Proposal for amendments to GRVA/2020/22

This document proposes amendments to GRVA/2020/22 with the aim of simplifying the proposal and harmonizing the amendments of all working documents aiming to amend UN-R79 ACSF of category C.

ACSFC – Case where the lateral movement is initiated automatically (1 Step HMI)

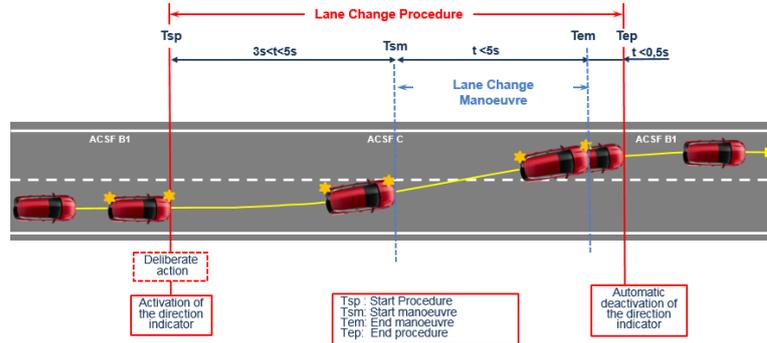
In case of an automatic initiation the lane change manoeuvre shall commence between 3.0 seconds and ~~7.0~~ ~~5.0~~ seconds after the manual activation of the procedure as described in paragraph 5.6.4.6.2. and shown in the Figure below.

The manoeuvre shall commence at the earliest opportunity without undue delay when the situation is not deemed critical as defined in 5.6.4.7.

ACSFC – Case where the lateral movement is initiated by a second deliberate action by the driver (2 Step HMI)

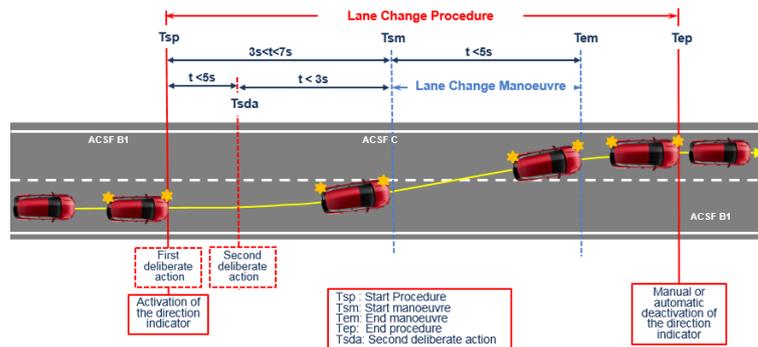
In case of an initiation by a second deliberate action the lane change manoeuvre shall commence between 3.0 and 7.0 seconds after the manual activation of the procedure as described in paragraph 5.6.4.6.2.

Additionally, the lane change manoeuvre shall commence at the latest 3.0 seconds after the second deliberate action as shown in the Figure below.

The control to operate the second deliberate action shall be located in the steering control area."
